Re: Ulan West Longwall 7 Infrastructure First Workings Request

Attachment 1- Ulan West LW 7 First Workings Amendments

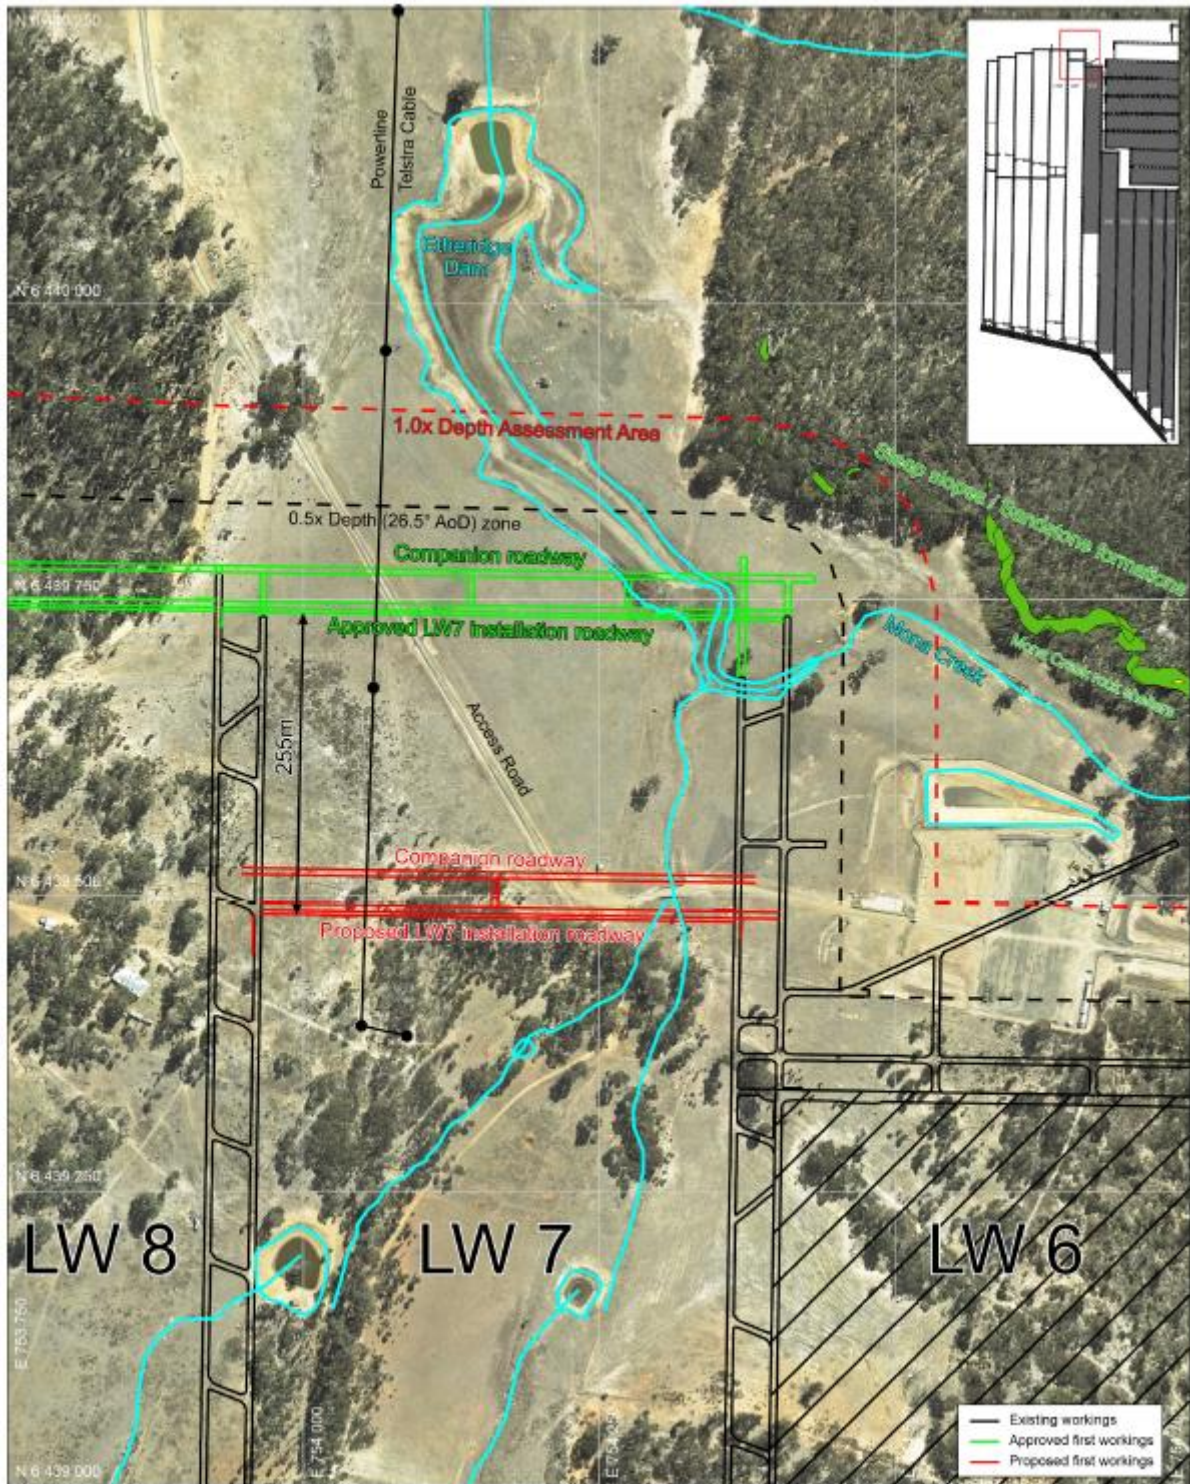
I am writing to request approval for a change to the approved first workings at Ulan West Operations (UWO), Long Wall (LW) 7. The proposed first workings amendment involves relocation of the installation roadway on the northern end of LW 7 to the south due to unfavourable mining conditions being identified at the location of the originally planned Installation Roadway position.

The proposed amendments to the first workings are shown in Figure 1, in Attachment 1 and involve relocating the installation roadway on the northern end of LW 7 to the south, by 255 metres. The proposed first workings amendments follow detailed geotechnical evaluations which reassessed the risk at the original planned installation roadway position. This identified that the continuation of mining and specifically formation of wide roadways within this area poses increased health and safety and financial risk to the mining operation. Moving the LW 7 installation roadway position to a more suitable location to the south by 255m significantly reduces these risks.
